Shin Shin Apparels Ltd. (9615)

27.MAY.2014

Identified Priority 1 Concerns

1st Priority 1 Concern

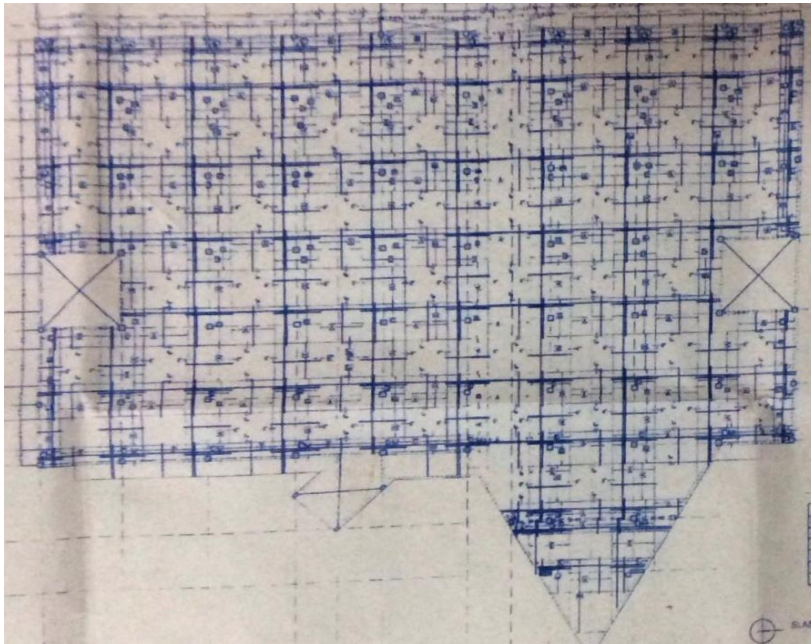
Based on the Detail Engineering Assessment report by BUET, the recommendation is using 1.5kPa (30psf) for live load for flat slab system due to the punching shear issued.

As per our calculation with the live load 1.5kPa for punching shear at the typical column, the shear stress at the first perimeter is higher than the design concrete shear stress. Based on the code, it must be increase the slab thickness or provide shear links for slab. However, the shear links have not provided as per structural drawing.

Furthermore, due to the lack of lateral stability system, the increase of un-balance moment due to lateral load need to be considered.

The span/depth ratio for flat slab which controls the limit of deflection for an RC element is defined apparently as $L/30$. The ratio for 7.62m span and 200mm thickness slab is 38 which was higher than ratio requirement.

Thinner flat slab will lead to increase the deflection in short-term and long-term and reduce the punching shear resistant as well.

The thin flat slab without drop panel and may be without shear reinforcement is not sufficiency to resist the punching shear load in seismic load which will cause the slab fall down suddenly and the building will collapse subsequently.

2nd Priority 3 Concern

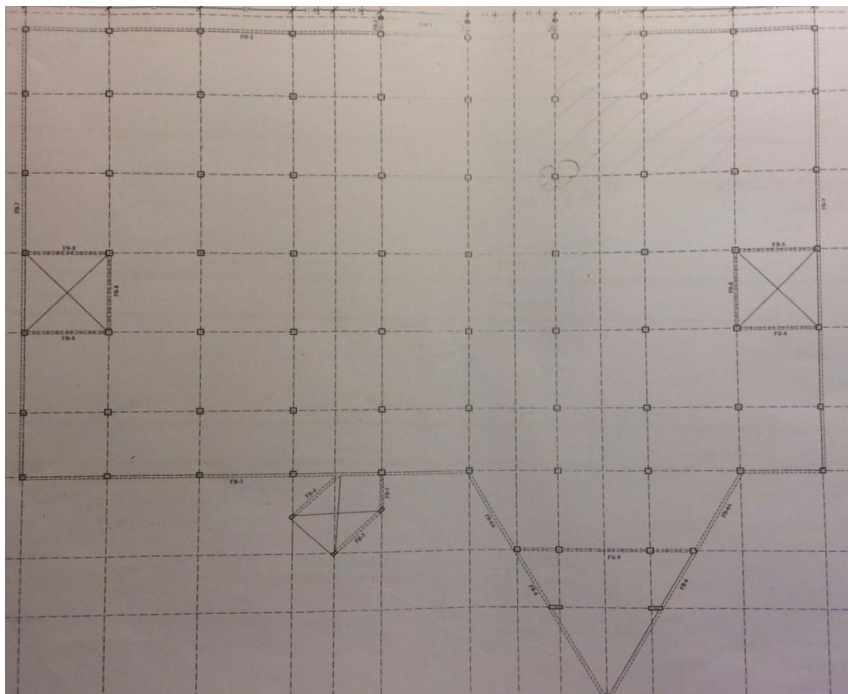
There is two water tanks 2m³ per each tank which was put beside the column.

As the 2nd floor is the flat slab, so the tank put beside the column will cause the concentrate load to the slab, and this will potential increase the punching shear to the slab.

The tanks should be put directly on the main columns, that will help the load will transfer to the column, not to the slab.
